Sinclair College
Building 14 – EMS Classrooms & Sim Lab
FAC 24-28X
Dayton, OH

ADDENDUM 01

Date of Addendum: January 31, 2025

This addendum consists of five (5) pages plus attachments.

1 CLASSROOM AV SYSTEM - LECTURE HALL 02
SCALE: 3" = 1'-0"

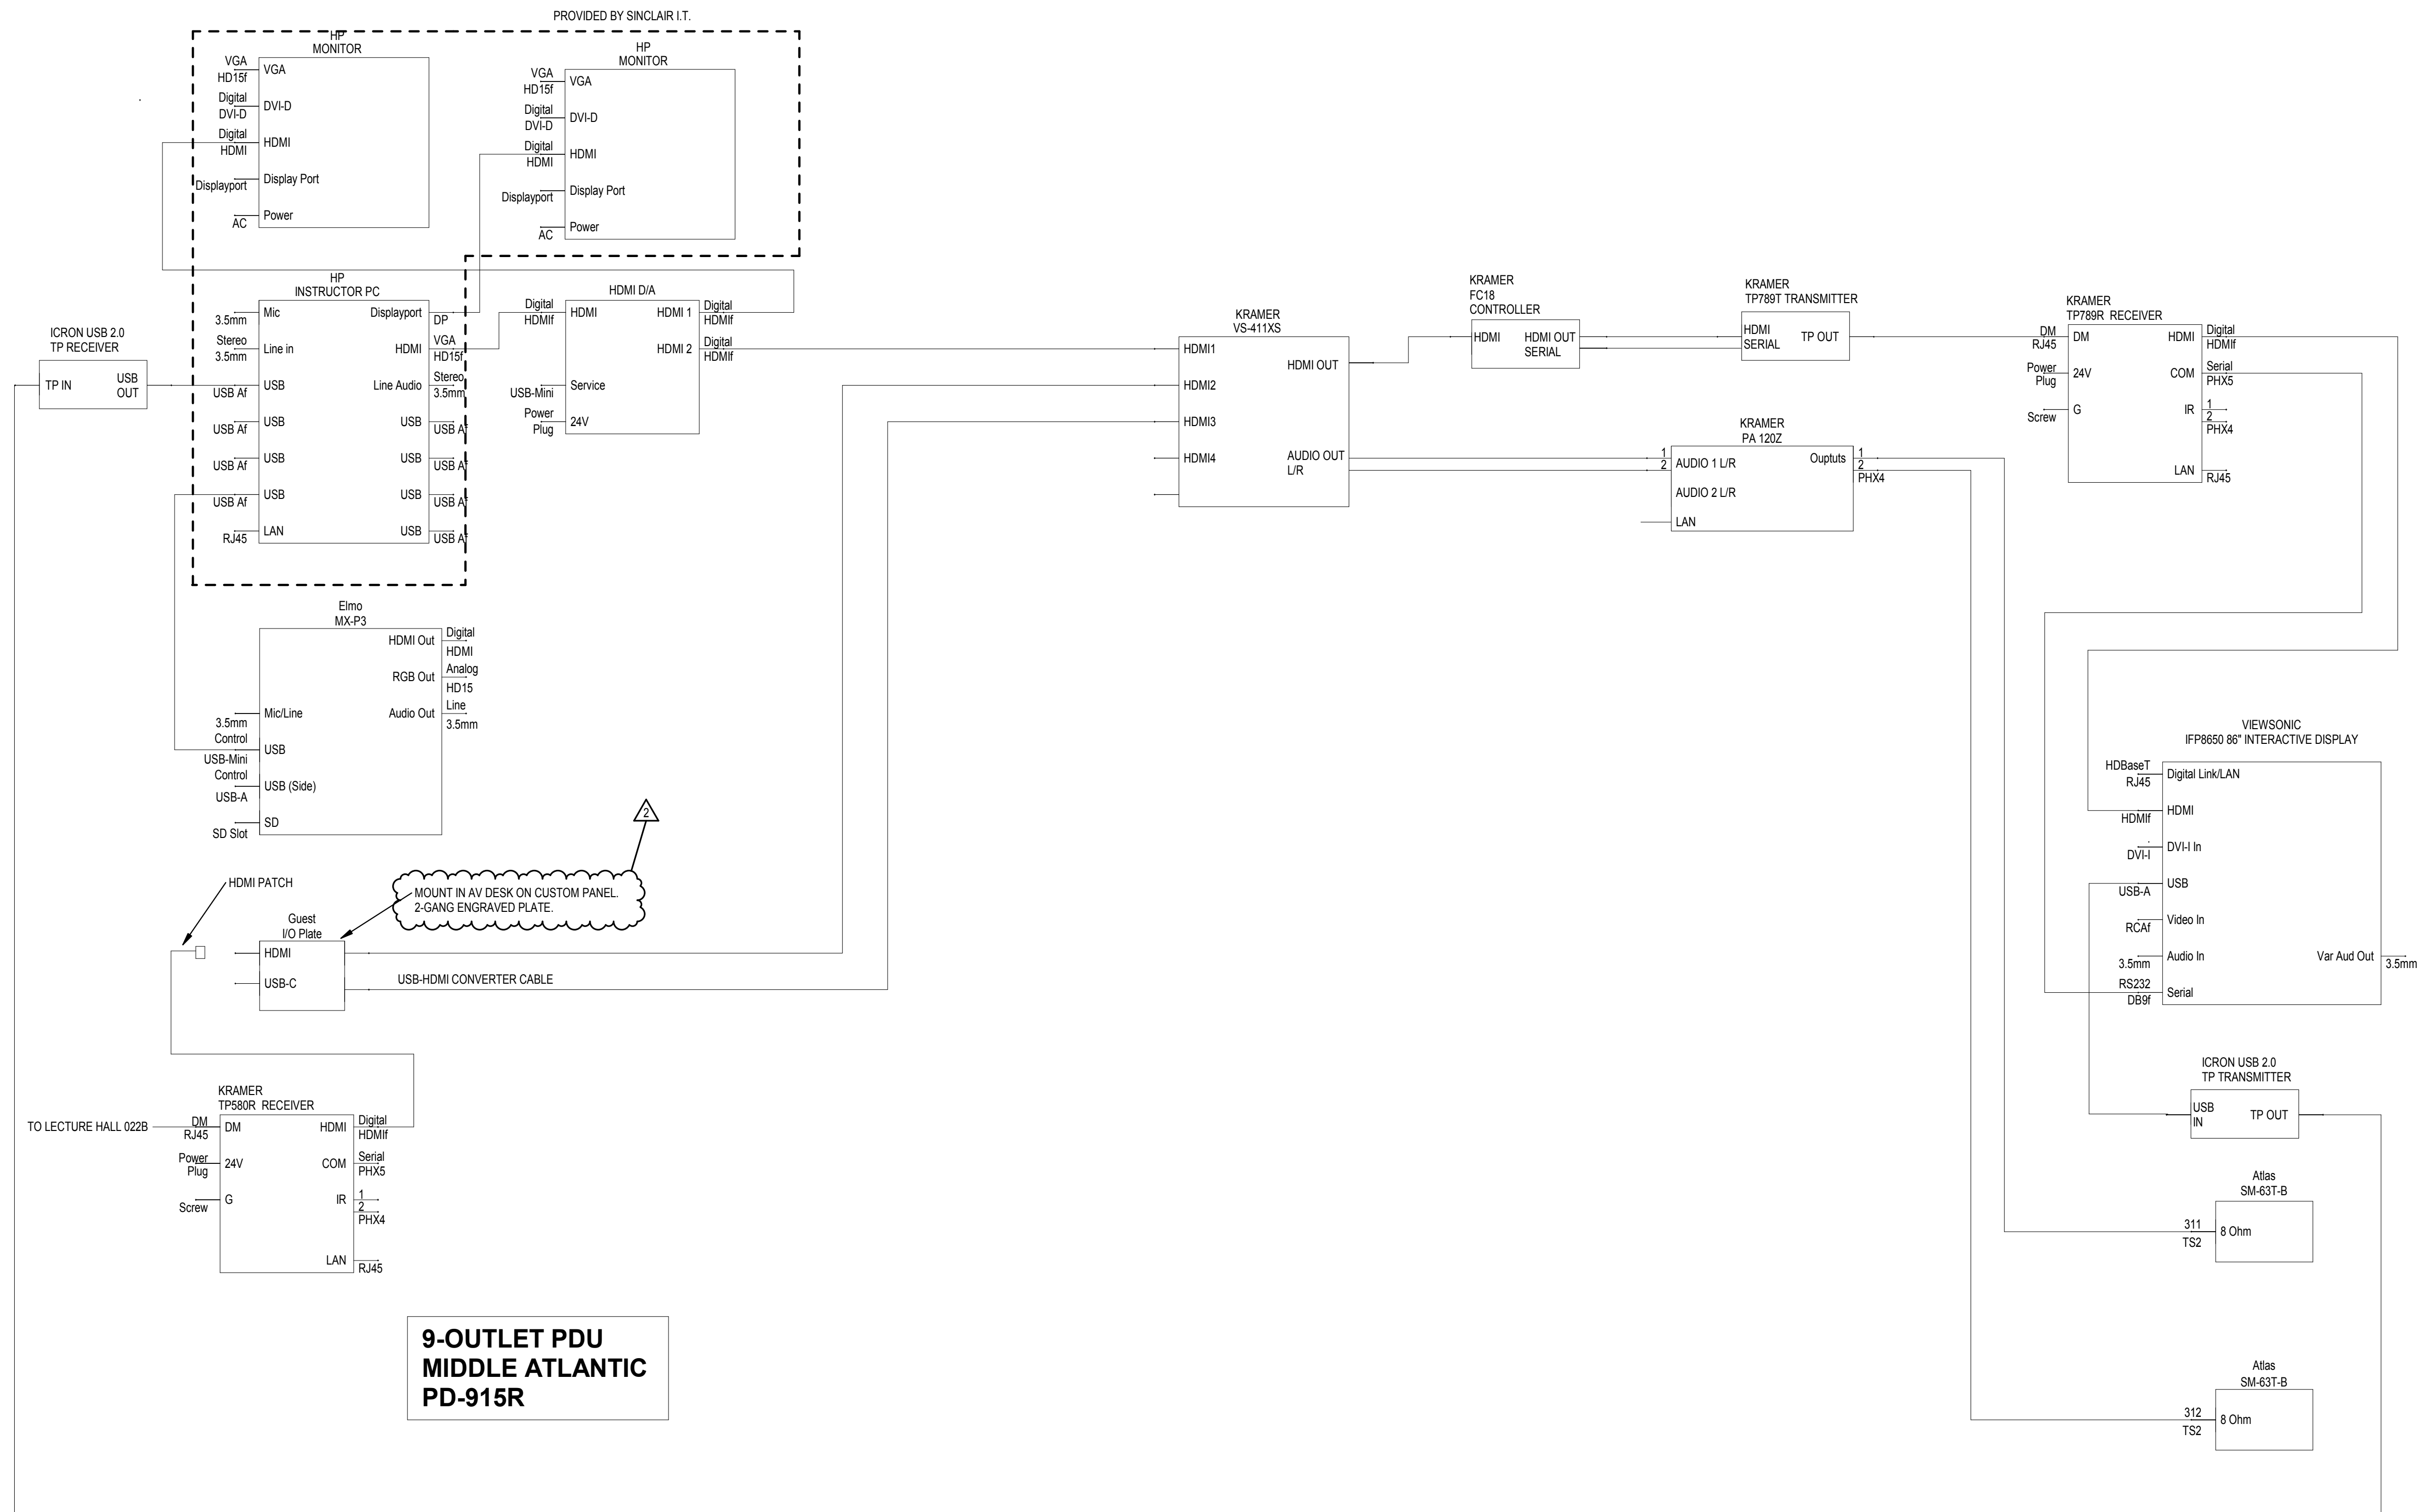
14. Sheet T005 AV SYSTEM DETAIL

- a. Add note to instructor input outlet to provide 2-gang engraved plate.

AV OUTLET TYPE C

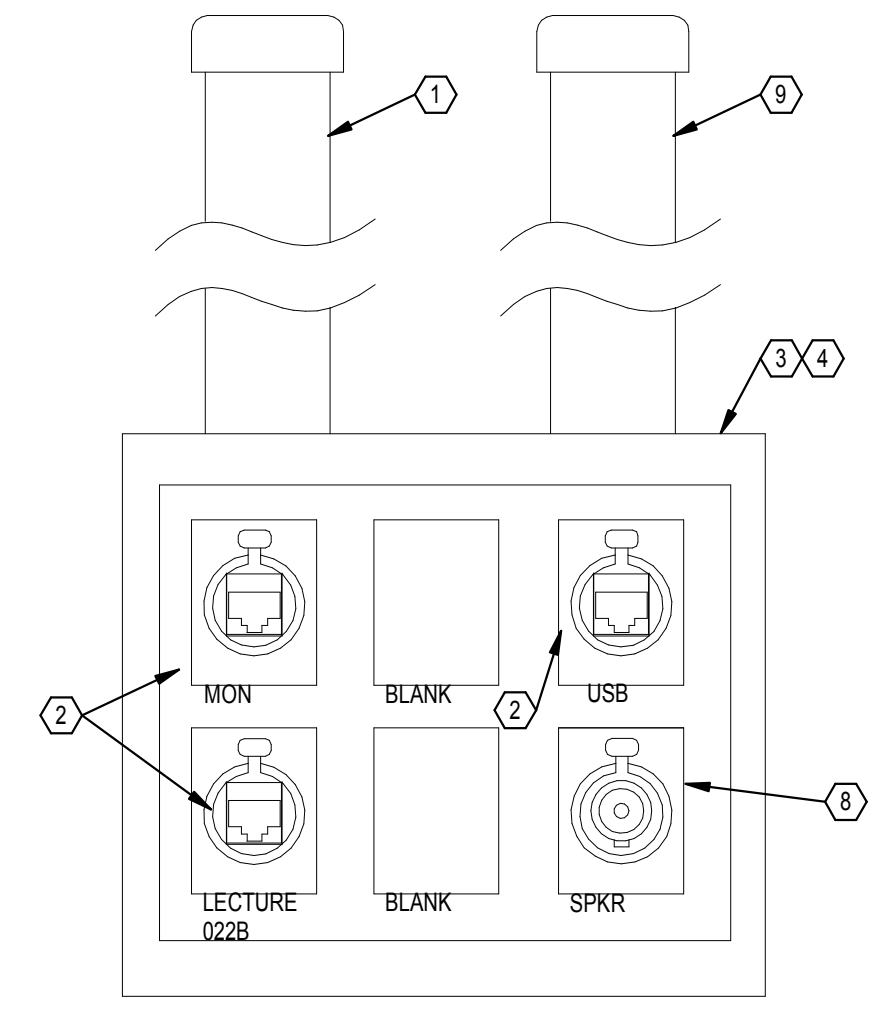
15. Sheet T006 AV OUTLET DETAILS

- a. Remove Ethercon jack from diamond V “C”
